RE: Agency Comments on Baseline Data Report Addendum 1, Roca Honda Mine, Permit Application No. MK025RN

**Roca Honda Resources Response to Agency 11/29/18 Letter and Comments
Re: Roca Honda Project Mine Permit Application No. MK025RN**

Agency Review of Roca Honda Resources Baseline Data Report Addendum 1, Revision 1 dated July 2018			
Reviewer: C. Chisler Agency: NM MMD		Review Date: November 29, 2018

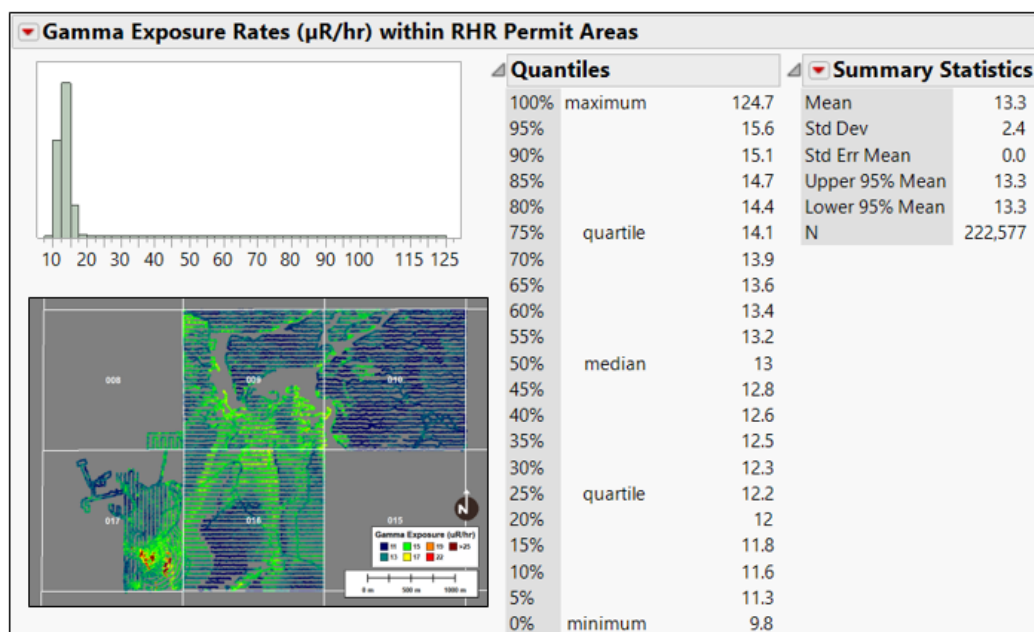
NMED Comment 7: *Appendix B: Considering the two studies presented herein, and the previous studies submitted by RHR, what is the site specific 95% confidence background level, to be achieved at the completion of mine activity. Please discuss and changes this number has undergone as a result of expanded baseline work presented to the coordinating agencies.*

RHR Response: The 2013 Post Mine Radiological Surveys Plan (SENES, 2013a) was submitted to MMD before 2014 draft guidance from MMD introduced a definitional criterion at the 95th percentile on baseline soil radionuclide concentration (MMD, 2016). For this reason, a site-specific 95th percentile on baseline gamma radiation survey measurements had not previously been calculated. In response to this

comment, relevant statistical summary information for all gamma survey data within mine permit areas is provided in the below figure.

The 95th percentile for baseline gamma exposure rates across the permit area is 15.6 $\mu\text{R/hr}$. The 2013 Post Mine Radiological Surveys Plan (SENES, 2013a) specifies different semi-quantitative spatial analysis criteria to identify and define areas that have become impacted by mining operations at the Roca Honda Mine site. In the event that a given area is determined to have been impacted by mining operations, this 95th percentile on baseline will be used to determine cleanup criteria in accordance with current MMD guidance on the matter (MMD, 2016).
